<p>Environmental Protection Agency An Ghníomhaireacht um Chaomhú Comhshaoil</p>	<p>OFFICE OF ENVIRONMENTAL SUSTAINABILITY</p>
ENVIRONMENTAL LICENSING PROGRAMME	
TO:	Dr. Eimear Cotter, Director
FROM:	Siobhán Egan, Inspector, Environmental Licensing Programme
DATE:	15 December 2020
RE:	Technical Amendment to Industrial Emissions Licence Register Number: W0165-02, held by Ballynagran Landfill Limited at Ballynagran Residual Landfill, Ballynagran, Coolbeg and Kilcandra, County Wicklow

The Agency received a request on 2nd March 2020 and on 24th June 2020 from Ballynagran Landfill Limited, Licence Reg. No. W0165-02, to technically amend their licence which were received as separate Technical Amendment requests but will be dealt with together (Ref. No. CR07557).

Appendix 1. Proposed red line boundary (Drawing number 1006-IG-18-19)

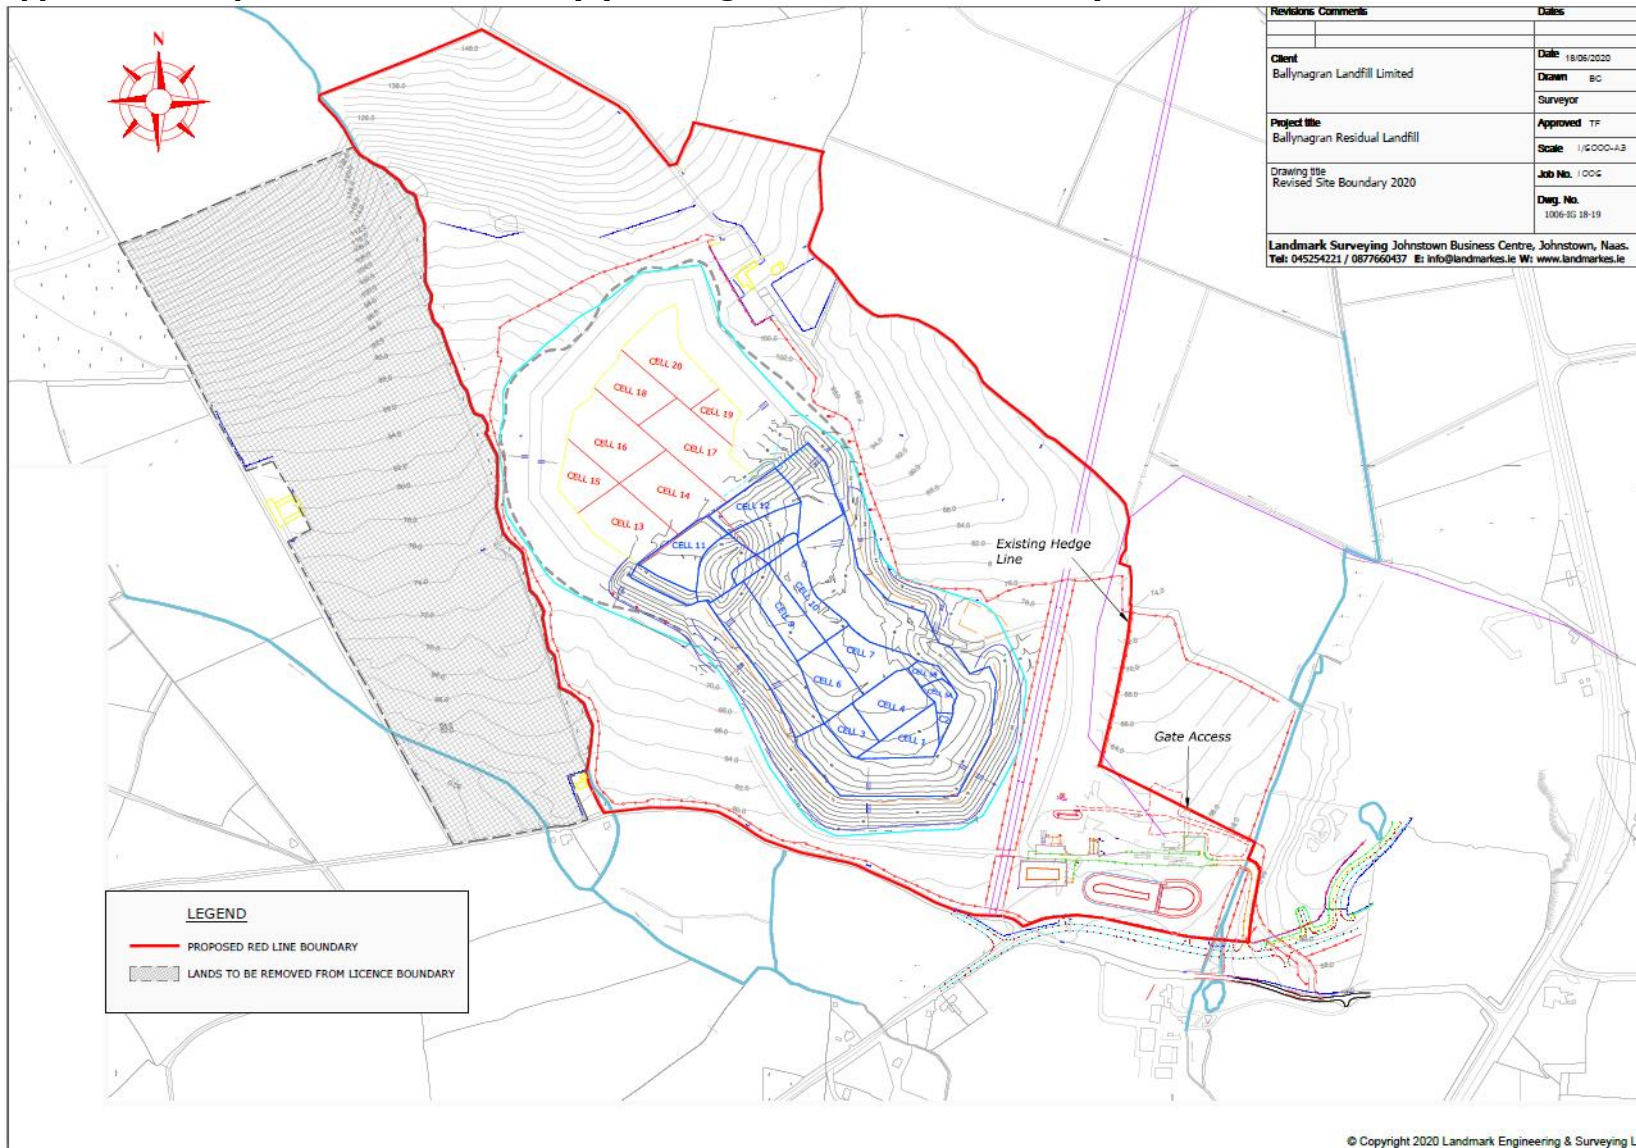
The licensee proposes to remove a further area of land comprising 29.81 hectares that would result in a change to the site buffer area and to the site boundary. The area proposed to be removed from the licensed boundary is shaded in grey in Appendix 1.

The area proposed to be removed is set out in drawing number 1006-IG-18-19 of licensee return ref. LR052051. The land consists mainly of well established agricultural grassland bordered by woodland which formed part of the buffer lands incorporated into the licensed area. No evidence of licensable activity occurring in the proposed area was evident on the day of the inspection. The licensee stated that they have had no access to the lands in question for approximately 12 years which was confirmed by the landowner and prior to that the lands were only accessed for monitoring reasons. The location of dust and noise monitoring points which were originally located within the proposed area were previously relocated with the agreement of the EPA due to lack of access by the licensee.

It is noted that the removal of lands as proposed would result in the width of the buffer area decreasing in this location to 60m, as a result the minimum Buffer Zone of a width of 100m, as required by Condition 3.13.1, would no longer be possible to enforce.

It is considered that the role of the buffer in this regard can be maintained with the reduction of the buffer width at this location. It is noted that there have been no changes to any receptors in the locality.

It is proposed that the buffer area is explicitly defined as the area between the installation boundary (as specified in Condition 1.2) and the landfill footprint as defined by Condition 5.1 which curtails activity to the identified cells within the landfill area only, requiring that:

On this basis it is recommended to amend the licence to exclude the identified area of land and reduce the buffer width from 100 metres to 60 metres at this location by;

- amending Condition 1.2 to specify a revised installation boundary removing the lands identified as follows:

*For the purposes of this licence, the facility is this area of land outlined in red on Drawing No. **1006-IG-18-19 entitled "Revised Site Boundary 2020"** of the technical amendment application received on **24th June 2020**. Any reference in this licence to "facility" shall mean the area thus outlined in red.*

*A Buffer Zone, in which no waste shall be landfilled, shall be provided and maintained within the facility. The Buffer Zone shall be ~~a minimum of 100m~~ **the area between the landfill footprint and the installation boundary.***
